MARCH 17, 2019

**Philipstown Planning Board**

Re: Garrison Gulf Gas Pump Canopy & Used Car Lot Application

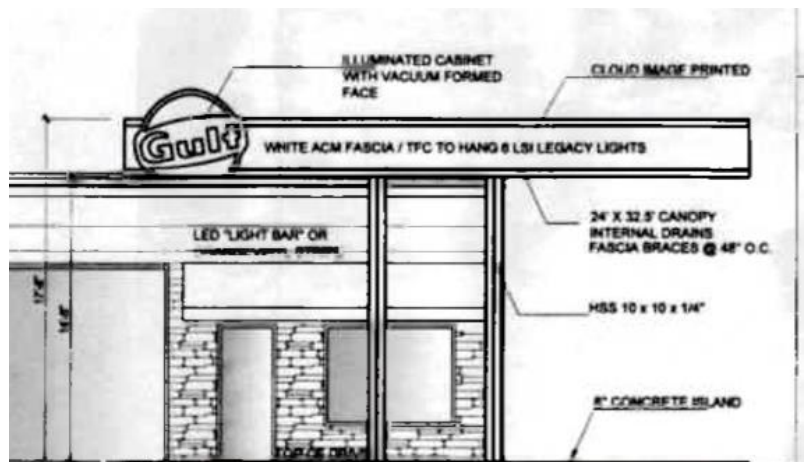
The images to the right show the proposed canopy design and a similar canopy in Cortlandt Manor. The design is very out of character with our neighborhood. It also appears there are plans to illuminate parts of the canopy. The description of outdoor lighting in the application is unclear at best. If construction of a canopy were to be approved, it should be required to use architectural designs and materials that are more appropriate.
